PUBLIC HEARING MEMORANDUM

SUBJECT: **Petition #179-13**, Beecher Terrace Homes, LLC., for a SPECIAL PERMIT/SITE PLAN APPROVAL to construct single-family attached dwelling(s) containing 5 units, to waive the 10-foot driveway setback requirements, and for a retaining wall greater than 4 feet located within a setback at **22 and 26 Beecher Terrace**, Ward 6, on land known as SBL 65, 8, 46 and 47, containing a total of 32,826 sf of land in a district zoned Multi Residence 1. Ref: Sec 30-24, 30-23, 30-9(b)(5), (a), (b), 30-5(b)(4) of the City of Newton Rev Zoning Ord, 2012.

MEMORANDUM

*Proposed 5 Units
22 & 26 Beecher Terrace
Newton, MA
Prepared by: Greater Boston Surveying & Engineering
Dated: March 25, 2013*

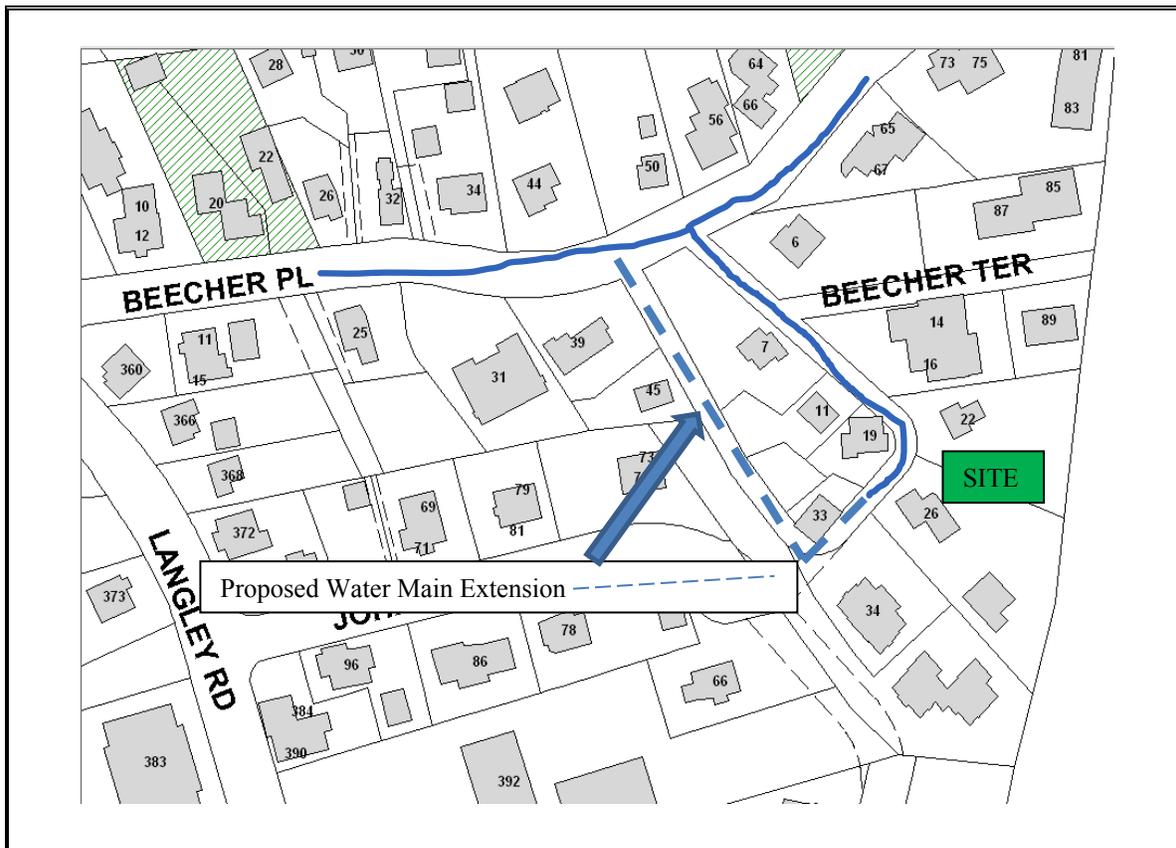
A retaining wall greater than 4' is proposed parallel to the southern property line, however; no indication of the wall height is referenced. Walls over 4' will need a safety fence.

As a Public benefit, the two concrete aprons that are totally destroyed at the Beecher Place & Beecher Terrace intersections should be replaced, and Beecher Terrace should be repaved. The proposed 10" CLDI pipe is not acceptable because the existing main in Beecher Place is only 6" main. However, the Director of Utilities has indicated that the main in Beecher Terrace is a dead end main and should ideally be looped back to Beecher

Finally, the plans submitted are not to correct scale this need to be corrected, furthermore; the plans are not very clear.

1. The engineer of record shows on site drainage improvements, however; no calculations or drainage report received at the time of this review. On site soil testing is required for the evaluation of the proposed drainage system. Test pits and percolation test(s) are required within 20-feet of each system, to verify groundwater elevations, and soil types.

2. There is a proposed overflow pipe directing overflow stormwater towards the abutting property to the east towards Chestnut Hill Condominiums; this is not acceptable since the flow condition is being altered from the existing condition as [sheet flow] to the proposed condition as a [point source] discharge. To remedy this situation the flared end section should be directed to an underground diffuser comprised of a perforated pipe embedded in washed crushed stone and filter fabric, and having an impervious barrier on the downstream side of the system.

3. The proposed overflow pipe from the driveway at unit # 1 to the catch basin in Beecher Terrace is not permitted. The engineer of record needs to demonstrate why the overflow is warranted and why the runoff from the site cannot be completely contained on-site.

4. A drainage analysis needs to be performed based on the City of Newton's 100-year storm event of 6-inches over a 24-hour period. All runoff from impervious areas need to be infiltrated on site, for the project. The design of the proposed on site drainage system needs to comply with the MassDEP Stormwater Regulations and City Ordinances.

7. The proposed dry well details need to specify “**crushed washed stone**”. The elevation of the bottom of the stone, bottom of the pipe and depth to groundwater table need to be labeled. A detail is needed with filter fabric - 3” layer of peastone on top of the system, and then covered over with filter fabric.

1. A detailed profile is needed which shows the existing water main, proposed water service(s), sewer main and proposed sewer service(s) with the slopes and inverts labeled to ensure that there are no conflicts between the sewer services and the water service. The minimum slope for a service is 2.0%, with a maximum of 10%. Pipe material shall be 6" diameter SDR 35 PVC pipe within 10' of the dwelling then 4" pipe per Massachusetts State Plumbing Code. In order to verify the slopes and inverts of the proposed service connection, two manholes of the existing sanitary sewer system need to be identified on the plan with rim & invert elevations. The crown of the service connection & the sewer main need to match.
